WEBSTER ISB
TYPE SA-380

Shop Drawing Submittal Review

Project Name: Webster University-**ISB**

Copies	No.	Description
1 PDF	265100E02	(Submittal No. 265100-005) – Indoor Lighting (& Outdoor Lighting)
		• EB, EK, RQ, & SA

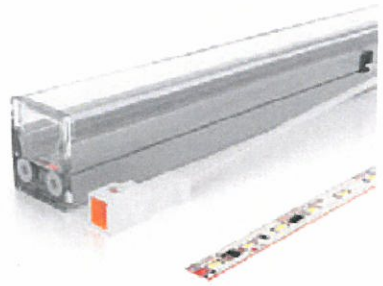
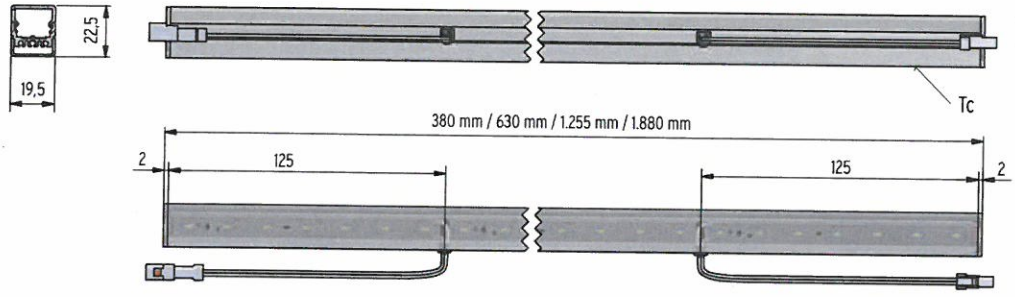
1. Coordinate all color finishes with architect.
2. Type EB: Provide W825 configuration. Coordinate and conceal wiring within guardrail to remote drivers. Provide 45 degree mounting clips. Contractor shall ensure fixtures are securely fastened to guardrail.
3. Type EK – Revise and Resubmit "D3" series in-lieu of "D4" series. This fixture is intended to aim downwards and be equipped with a lens to diffuse the view into the fixture.
4. Type RQ – Coordinate installation with existing fixtures.
5. Type SA – Revise and Resubmit. Submit Hydra LD25 linear product in-lieu of Xooline pre-configured product submitted.
